**RE: RESPONSE TO FURTHER ADVICE
193 BEAMS ROAD, TAIGUM QLD 4018**

This correspondence and the associated attachments provide a full response to the Further Advice that was issued by the Brisbane City Council (the **Council**) on the 27 April 2026.

Figure 1 – Approved (left) and Proposed (right) COS Deep planting

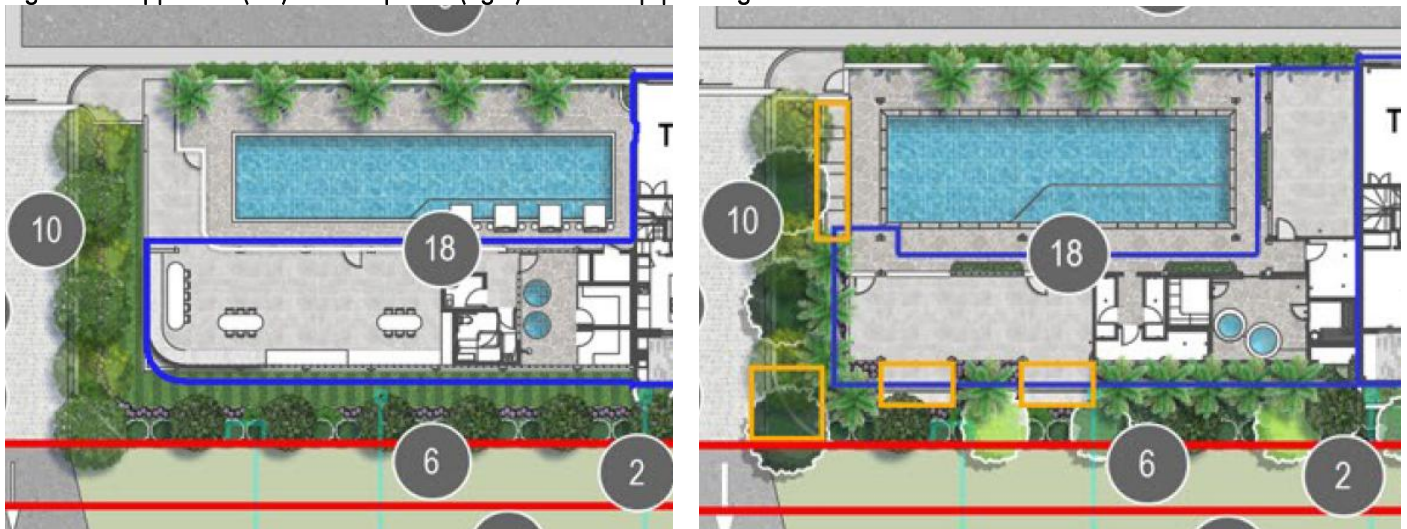
It is acknowledged that the submitted Assessment report has identified that an overall increase in site area provided as deep planting is proposed. However, after a detailed review of the amendments to the deep planting areas, it appears that many of the previously approved deep planting areas to the site frontage and eastern side boundary have been reduced in size, or the shape has been changed resulting in less functional deep planting areas, or infrastructure such as bin stores are in deep planting areas. It is also noted that the Landscape concept plan does not provide large shade trees in some areas which have been nominated as deep planting and there are now encroachments proposed into the limited areas of previously approved 4m x 4m deep planting. Of particular concern is the proposed encroachment of the communal open space into the deep planting area along the site frontage.

Submit revised drawings (architecture and landscape) in accordance with PO28 and PO29 of the Multiple dwelling code which show:

- a) Dimensions of site frontage and eastern side boundary deep planting areas in accordance with the current approval with currently proposed encroachments removed.
- b) Large subtropical shade tree plantings to all identified deep planting areas noting that trees and refuse collection points are to be located to avoid conflict.
- c) Deep planting areas free of conflicting infrastructure and hardstand, such as (not limited to) bin stores and bike parking.
- d) Ensure that the architecture and landscape plans are consistent with each other.

The approved deep planting arrangement surrounding the front communal open space area includes a 2m wide planting area and an adjoining 2m wide lawn area, as shown in **Figure 1**. The amended design seeks to better integrate the communal open space facilities within the available planting area. Rather than providing two broad zones of planting and lawn, the amended design includes an undulating planting area that ranges from 2m to 4m in width. This alternative design provides a greater quality of subtropical landscaping by replacing areas of lawn with more substantial planting and will immerse users of the front communal open space area within a lush landscaped environment.

Notwithstanding this improved amenity outcome for the communal open space area, Council's concerns regarding the available root zone within this frontage deep planting area are acknowledged and hence soil cells are now provided beneath the seating areas. This will ensure that a consistent 4m wide root zone is maintained along the full width of the frontage.

Overall, the amended arrangement is considered to provide an enhanced design outcome, as it increases the extent of dedicated planting within the 4m zone and improves the relationship between deep planting and the communal open space area, while maintaining a root zone and the ability to achieve canopy trees that is consistent with the approved outcome.

Figure 4 – Façade Variation

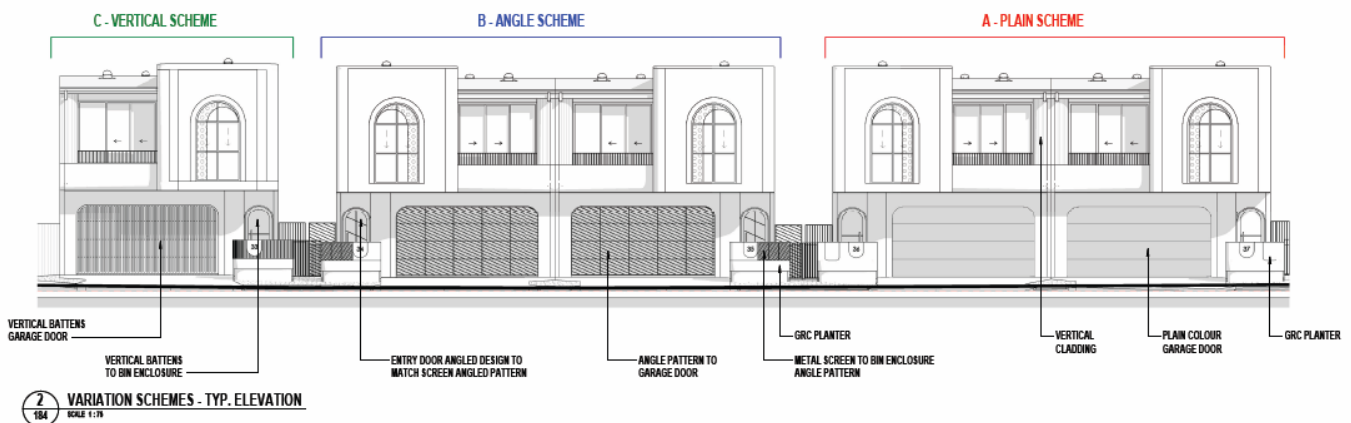
The proposal to amend architectural conditions 11, 79 and 135 – Final External Detailing of Building, is not currently supported because the submitted plans do not adequately address the accepted or performance outcomes relating to building bulk, form, variation and articulation. The overall site elevations and internal site elevations demonstrate that the built form is simplistic and repetitive, and updated documentation indicates a reduction in variation of materiality with CLD-02 essentially being a minor variation in rendered finish. These changes do not adequately address breaking down building bulk or assist in wayfinding within the development.

- a) Provide updated plans which include additional variation in the built form and external detailing via changes in materials, textures, and colour, addressing the requirements stipulated within conditions 11, 79 and 135.

As per the further discussions that have been held with Council, MAS has reviewed opportunities to provide additional architectural variation throughout the site while maintaining the overall design intent of the development. The amended architectural response provides additional variation to key repeated façade elements discussed with Council, including the front entry doors, garage doors and bin storage enclosures. It is understood that MAS and Council's Architect have liaised to confirm that the architectural variation adequately responds to this item of the Further Advice letter.

Given the applicant's need to progress operational works for the site, it is requested that Conditions 11, 79 and 135 be amended to reference the submitted architectural variation diagrams. A full set of amended site elevations will then be provided as part of the subsequent compliance assessment required by these conditions.

Figure 5 – Approved (left) and Proposed (right) Screening

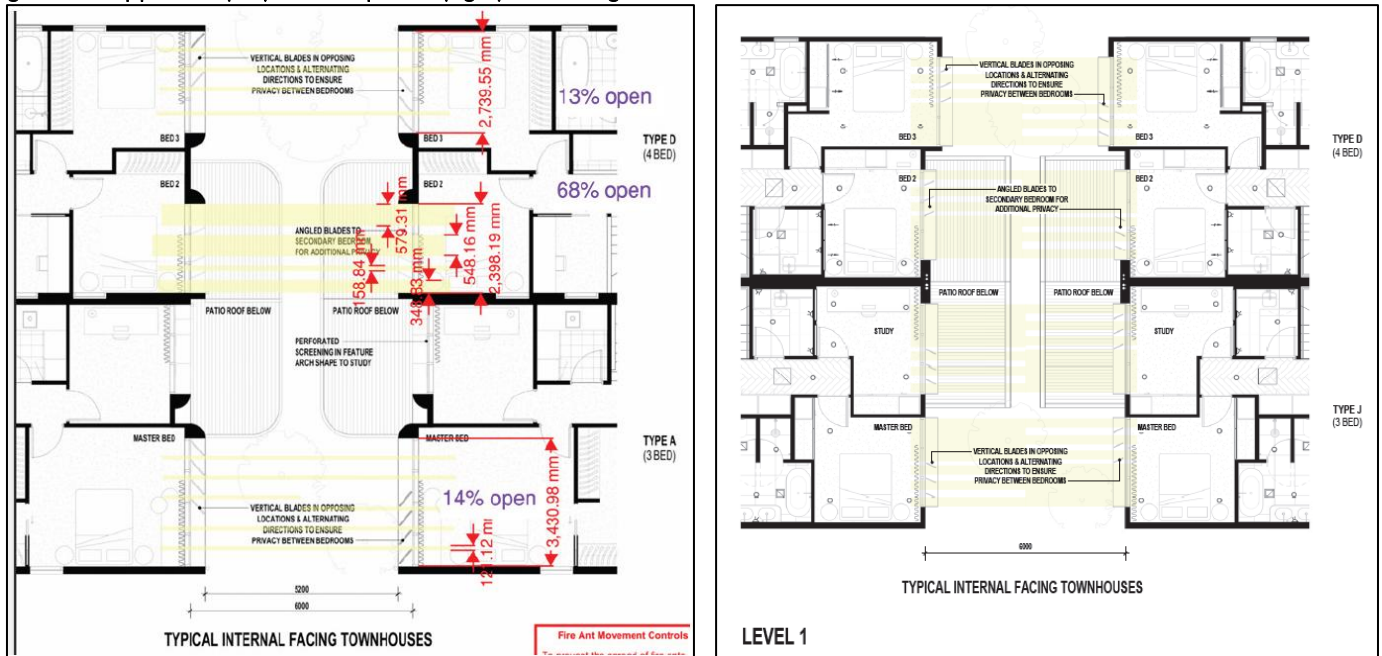
The proposed privacy solution between internal buildings which are separated by <math>< 9\text{m}</math> includes a departure from the approved plans, due to the changed internal configuration and spacing of screening components, which means the potential privacy and overlooking impacts are worsened. The amended plans do not currently achieve PO3 or PO17 of the Multiple dwelling code.

- a) Amend the design of the privacy screening to match or exceed the outcomes of the previously approved privacy solution.
- High order importance should be placed on bedrooms for privacy treatment
 - Reduce the spacing of angled privacy blades to reduce overlooking
 - Provide privacy solutions to all bedrooms effected.

(see below comparison image – proposed on left, approved on right)

Please refer to the amended architectural plans prepared by MAS. The amended plans resolve the previous drafting error contained in the submitted plan package relating to the spacing and configuration of privacy screening between internally facing townhouses. Privacy screening has now been reinstated to maintain a consistent privacy outcome in accordance with the approved plans of development.

Figure 7 – Amended corner and Common Bin collection Areas.

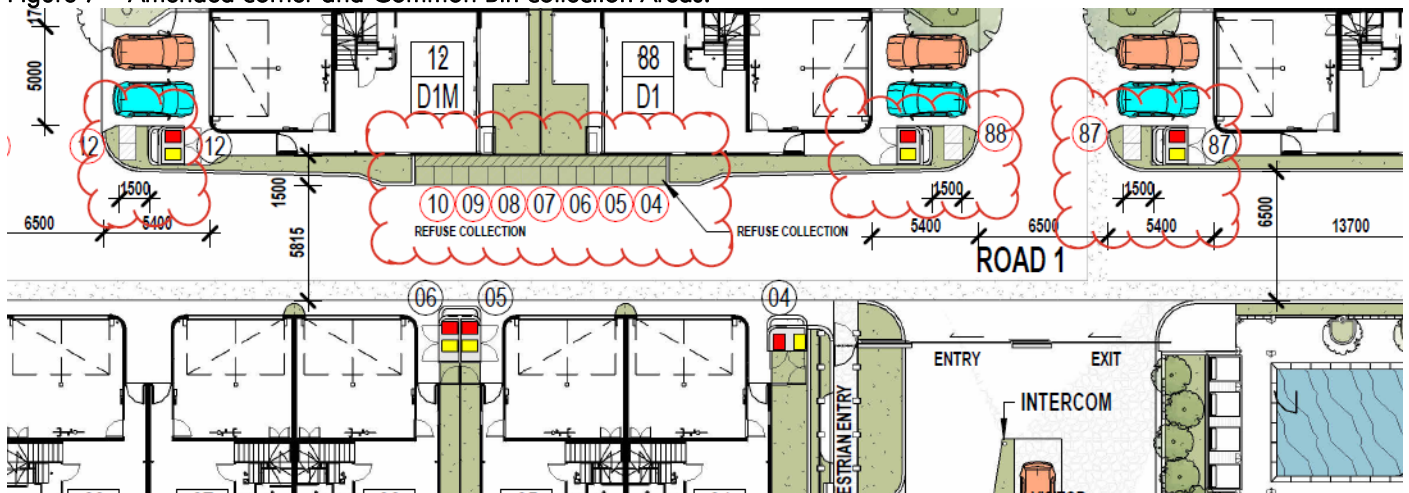
Amend the Site Plan – Setbacks, Roads and Refuse – to demonstrate bins can be adequately stored and collected. Refer to markups in red attached drawing.

- a) All 10 corner MGB Collection pads are too close to building assets to be safely collected. The setback is less than 1.5m and next to a wall. This is unsafe for collection purposes. All bin presentation locations on corners create difficulties with the RCV swing arm when collecting MGB's, i.e., the bins are too close to residential assets. Amend the design so that the RCV lifting arm / grab claws will not result in property damage to the MGB storage rooms, with minimum verge widths of 1.50m. This may involve either setting back the MGB storage room from the kerb-line or rotating the storage room or removing/repositioning the planter box to provide sufficient kerbside space for the collection services to operate safely, i.e., setback with similar setbacks to the THs in the same row.

- b) MGB presentation area (Road 1, TH 4 to 10 collection zone), must be safe and setback from TH buildings. The setback is less than 1.5m and next to a wall. This is unsafe for collection purposes. Ensure all bin presentation areas are an absolute minimum verge width of 1.50m so that the RCV's swinging lifting arm / grab-claws do not cause impact damage to the residents building and that the MGB's are safely located within the road pavement and protected from traffic by kerb/verge build-outs.

As per the further email and verbal correspondence with Council, it has been confirmed that the bin collection areas can be maintained on the corners, as previously approved, where a minimum 1.5m clear collection area is provided. The applicant has reviewed Council's comments and amended the design accordingly to provide a clear 1.5m wide area for bin presentation. This has been achieved through minor adjustments to the internal pedestrian pathways of townhouses.

It is noted that Council have also confirmed a preference for alteration of the common refuse collection zones for Townhouses 4 to 10. The amended design now provides a 1.5m wide grassed bin presentation area to support safe and efficient collection on bin collection days. Council agreed to a reduced aisle width in this location to allow the fully grassed presentation area to be provided.

It is acknowledged that this arrangement differs from the previously approved and negotiated bin location/collection outcomes. Notwithstanding this, the applicant has fully accommodated Council's preferred amended collection arrangement in the required locations.
